# CHABOT- LAS POSITAS COMMUNITY COLLEGE DISTRICT

## **Addendum No. 1 INVITATION FOR BID NO.: 11-07 Industrial Technology Center, Buildings 1400/1600 Renovation - Chabot College**

SCALE: 3/16"=1'-0"	TITLE: MECHANICAL YARD ENLARGED PLAN	DATE: 07-15-2010	
COLLEGE DISTRICT: CHABOT-LAS POSITAS COMMUNITY COLLEGE DISTRICT PROJECT : INDUSTRIAL TECHNOLOGY CENTER BLDGS 1400/1600 RENOVATION ADDRESS: 25555 HESPERIAN BLVD HAYWARD, CA 94545		DSA APP # : 01-110976 DSA FILE # : 1-C2

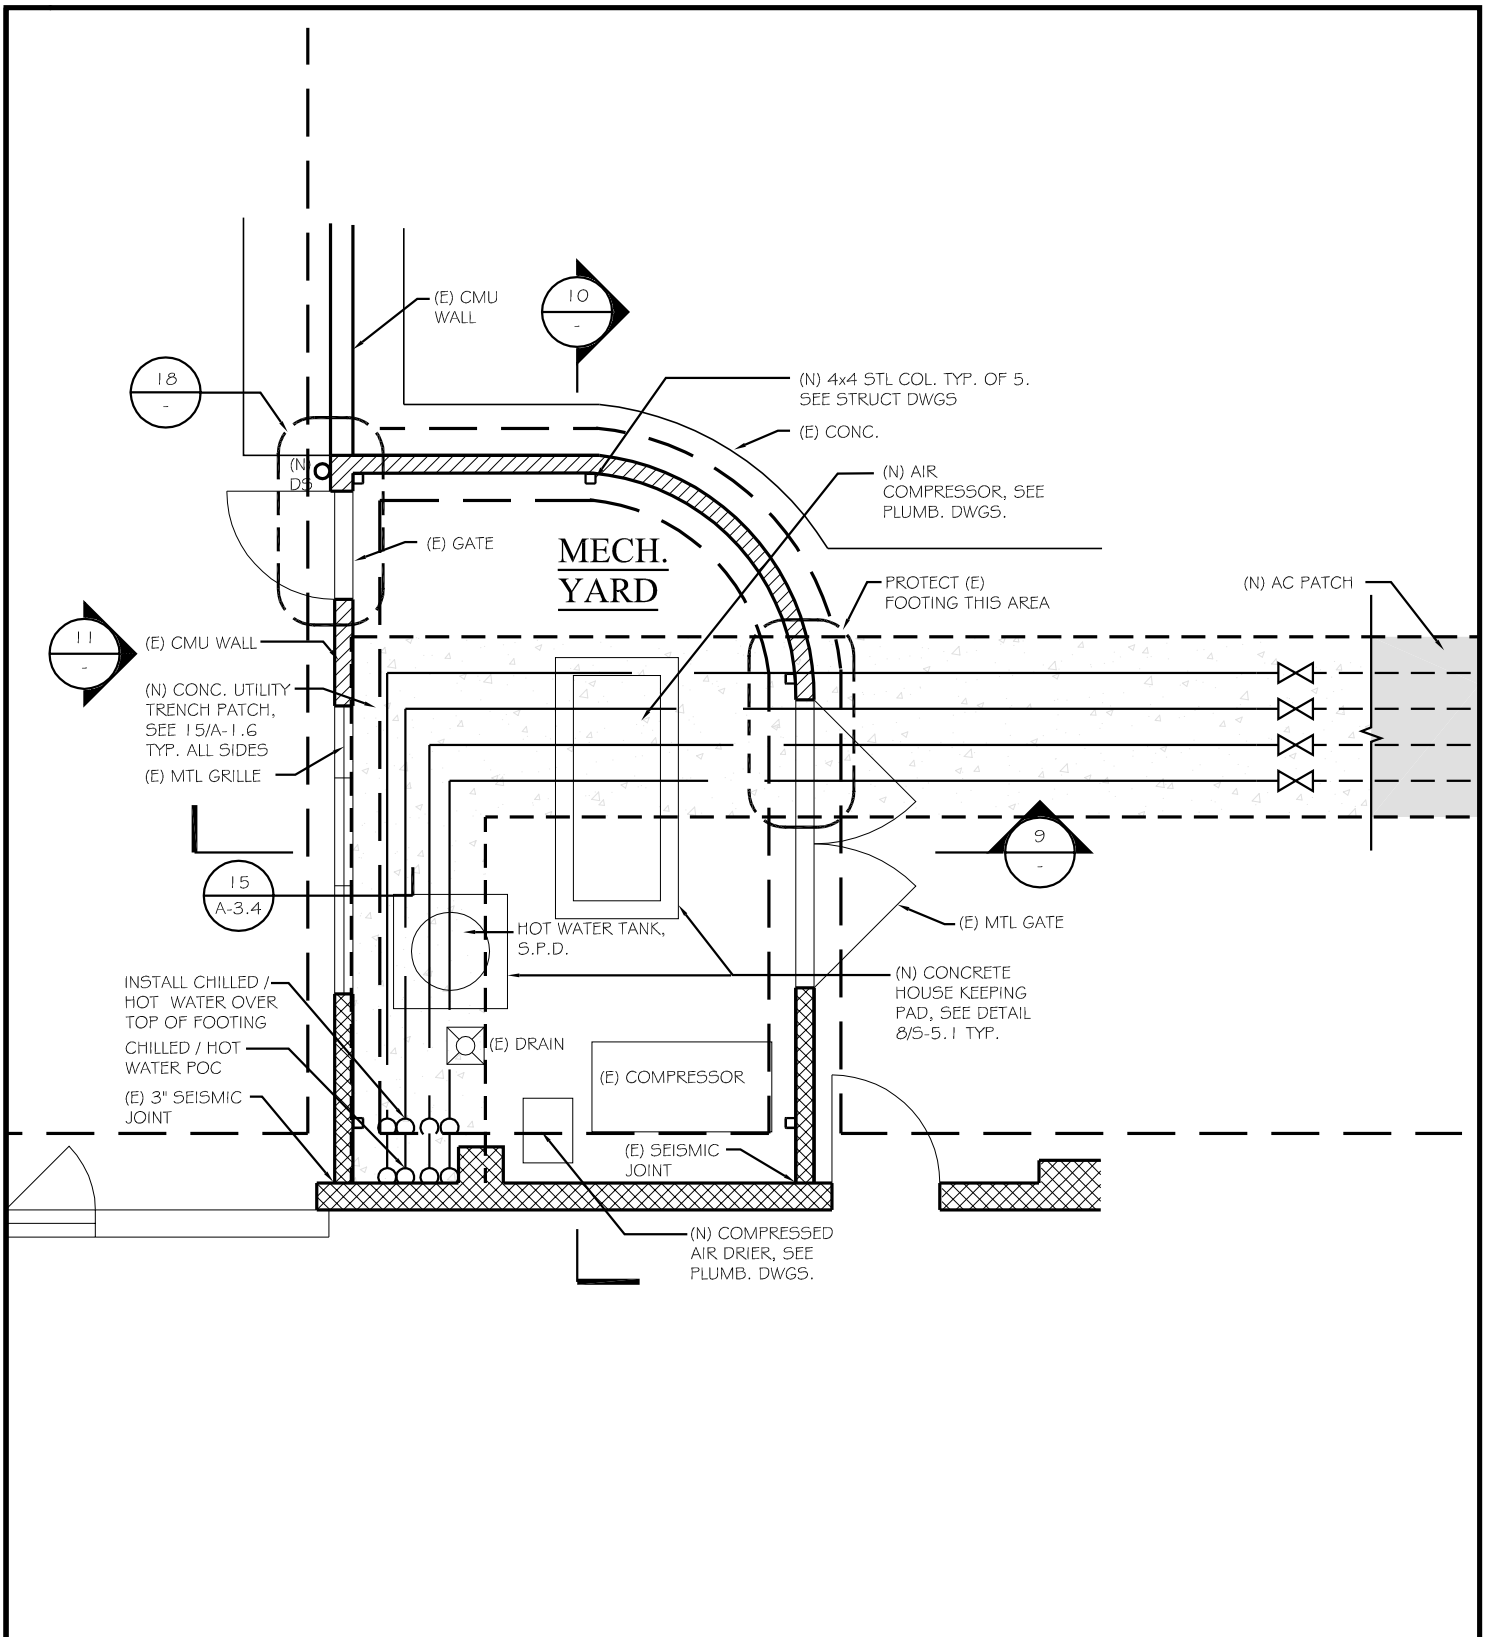
14. Drawing A-2.13 ENLARGED MECH YARD PLAN & DETAILS  
- BLDG 1400
  - a. Details # 1 replace detail with (N) detail AX-1. Correct layout for hot & chilled pipes is shown.
